**PERMIT**  
**SEWAGE DISPOSAL SYSTEM**  
HOWARD COUNTY HEALTH DEPARTMENT  
BUREAU OF ENVIRONMENTAL HEALTH  
410-313-2640

\_\_\_\_\_Jack Fyock Septic Service\_\_\_\_\_ IS PERMITTED TO INSTALL X ALTER \_\_\_\_\_  
ADDRESS P.O. Box 89, Glenelg, MD 21737 PHONE 410-988-9270  
SUBDIVISION Malcolm Property LOT NUMBER 7 ADDRESS 11962 Queen Street  
PROPERTY OWNER Mark Schwartz PROPERTY OWNER'S ADDRESS 609 Hollywood Avenue  
SEPTIC TANK CAPACITY 1250 GALLONS \* WATERTIGHT SEPTIC TANK REQUIRED \* 20904  
PUMP CHAMBER CAPACITY \_\_\_\_\_ GALLONS  
NUMBER OF BEDROOMS 4  
SQUARE FEET PER BEDROOM 210  
LINEAR FEET OF TRENCH REQUIRED 280

514982-B

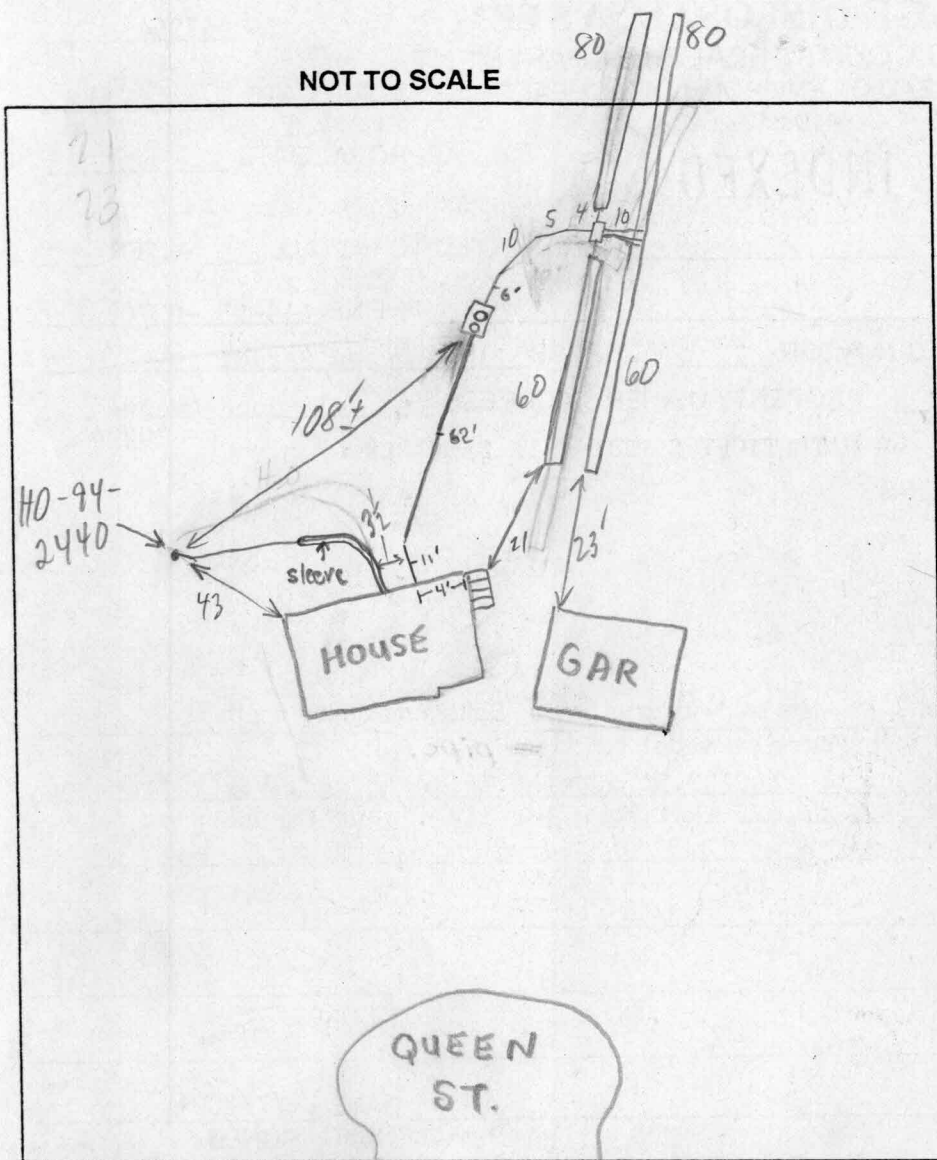
PRE-CONSTRUCTION INSPECTION: 4/24/01-MET INSTALLER FOR LAYOUT, OK TO RUN 2-80' TRENCH  
AND TWO 60' TRENCHES. INSTALLER TO ADD MANHOLE RISER AND OK TO COVER FROM  
HOUSE TO TANK-SRM  
 INSPECTION COMMENTS: 4/25/01 OK TO COVER ALL (MR)

4/25/01 WPI=2-PC CAP, PITLESS, GROUT & TAG OK; NOT INSTALLED NOT APPROVED  
 CONDUIT, SLEEVE @ HOUSE (MR)  
 INSPECTOR M. Rifkin DATE SYSTEM APPROVED 4/25/01
